From: [Harris, Matthew \(Ecology Officer\)](#)
To: [Jenny Singh](#)
Cc: [Cooke, Jacob \(Senior Planning Officer\)](#)
Subject: RE: Celtic Lakes Grassland Compensation Area
Date: 18 September 2024 12:18:41
Attachments: [image001.png](#)
[image002.png](#)

From: Jenny Singh <Jenny.Singh@arup.com>
Sent: Tuesday, August 13, 2024 10:51
To: Matthew.Harris@newport.gov.uk <matthew.harris@newport.gov.uk>
Cc: Jennifer.Low <Jennifer.Low@gov.wales>; lindsay.neville <lindsay.neville@gov.wales>; David Leak <David.Leak@arup.com>
Subject: Celtic Lakes Grassland Compensation Area

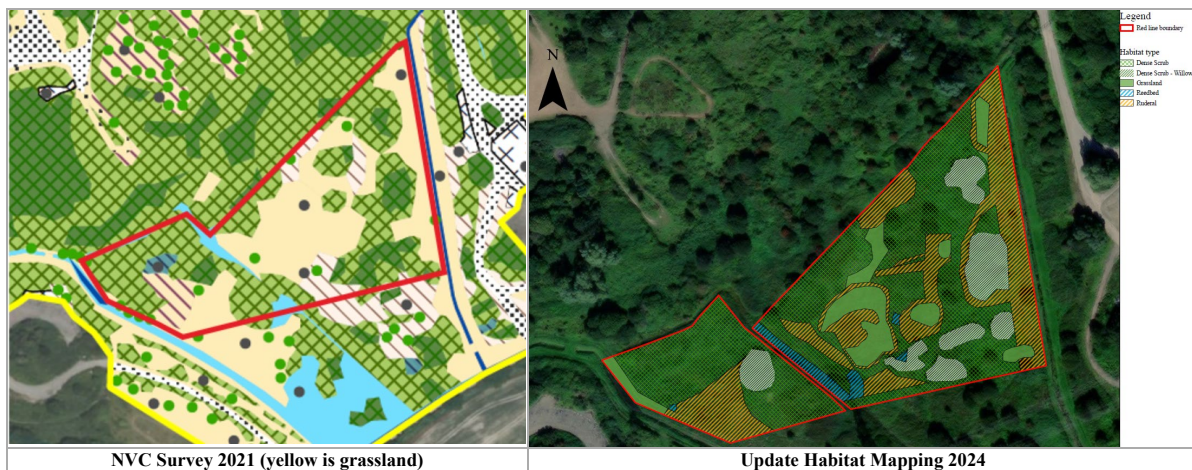
I agree with your analysis below that the existing grassland in the Grassland Compensation Area is of low condition and that it can be enhanced with suitable management. I also agree that the extent of this grassland can be increased by the removal of low-lying scrub and tall ruderals. The resulting grassland compensation is sufficient in terms of extent to meet the requirement set out in our Wildlife & Development SPG for a 1:1.5 ratio of habitat lost : re-created.

The location of the grassland restoration / re-creation compartments as set out below are logical in that they allow for larger more coherent areas of grassland, while retaining scrub of value for Dormice, rather than attempting to micro-manage a more granular mosaic of grassland and scrub.
